MODEL NAME	V/Hz	DESTINATION	CODE	SERIAL NUMBER
Ricoh NC8115	115 / 60	USA, CANADA	A105-17	
Ricoh NC8115	230 / 60	EUROPE	A105-27

MODIFICATION BULLETIN NO. 5

To comply with the CE mark standards, the following modifications have been made.

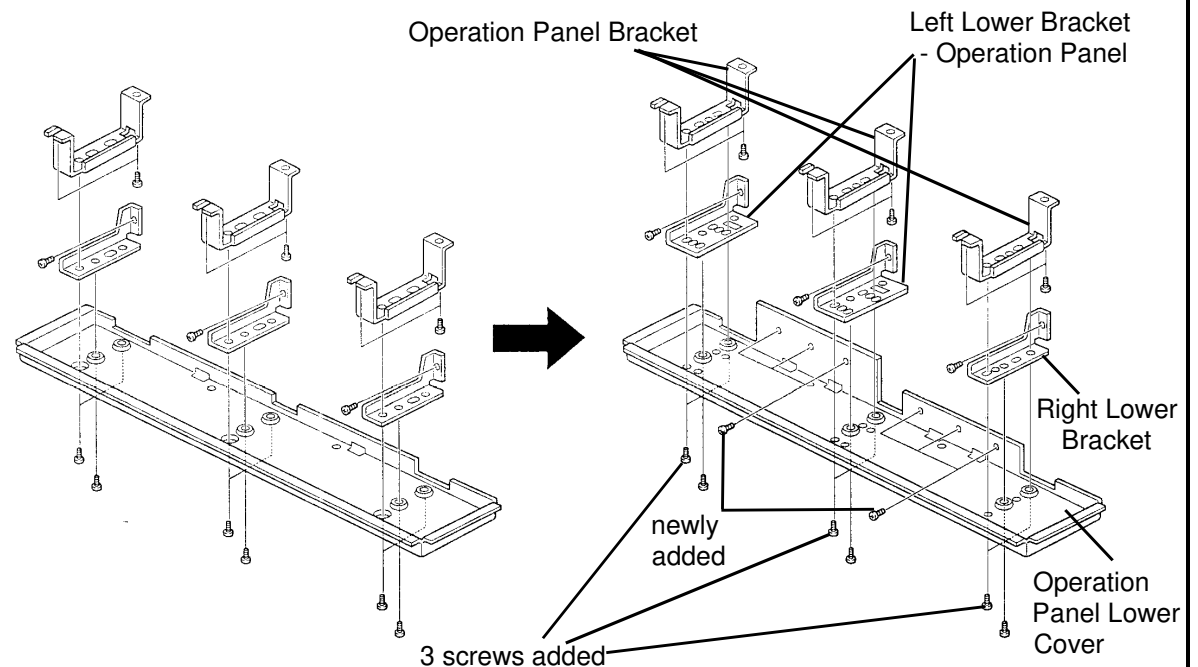
1. To improve grounding, two screws have been added to secure the rear left cover. Also, the IPU cover seal and seal 9.5x9.5x125 have been added.

OLDNEW

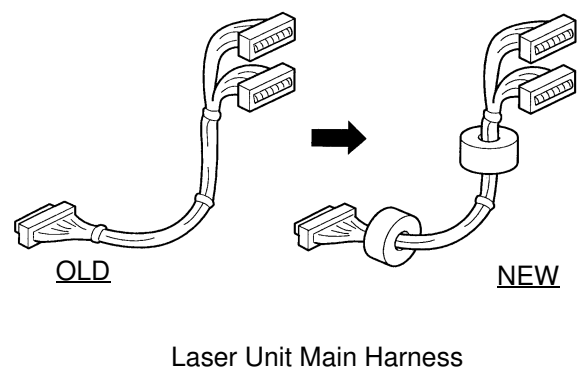
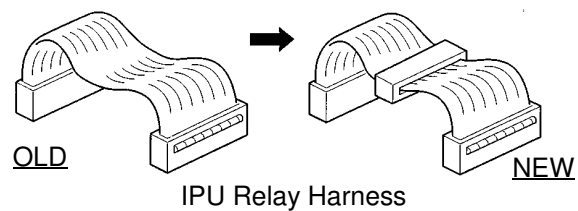
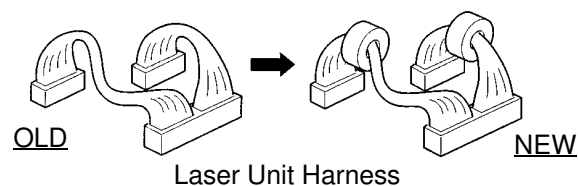
2. To improve grounding, six screws have been added to secure the operation panel lower cover to the main frame. To improve grounding, three screws have been added to attach the operation panel assembly to its brackets.

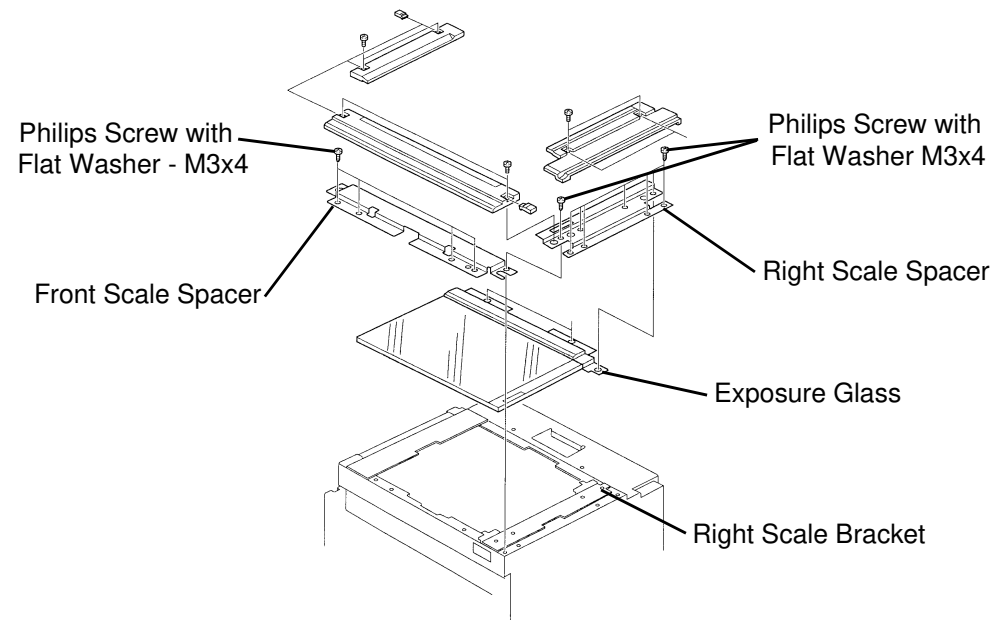
3. To reduce electrical noise, ferrite cores have been added to the IPU relay harness, the laser unit main harness, and the laser unit data harness. A ferrite core (P/N 16070881) has been added also to the LED harness inside the editor board.
